Microcomputer Technical Information

PG-FP4 Microcontroller Flash Memory Programmer Usage Restrictions		Document No.	ZBG-CD-04-0016	1/2
		Date issued	June 11, 2004	
		Issued by	Development Tool Group Multipurpose Microcomputer Systems Division 3rd Systems Operations Unit NEC Electronics Corporation	
Related documents	PG-FP4 User's Manual: U15260EJ4V0	Notification classification	√	Usage restriction
				Upgrade
				Document modification
				Other notification

PG-FP4 Microcontroller Flash Memory Programmer Usage Restrictions

No.2 IIC communication adapter board is not included

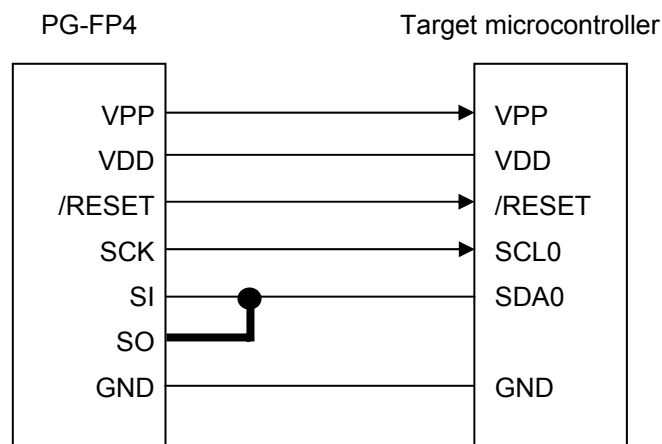
The IIC communication mode adapter board is not included.

When using IIC communication mode, short the SI and SO pins in the PG-FP4.

The IIC communication mode adapter board is included in products with control code C (firmware: V1.17, GUI: V2.00) or later.

Use the IIC communication mode adapter board for IIC communication.
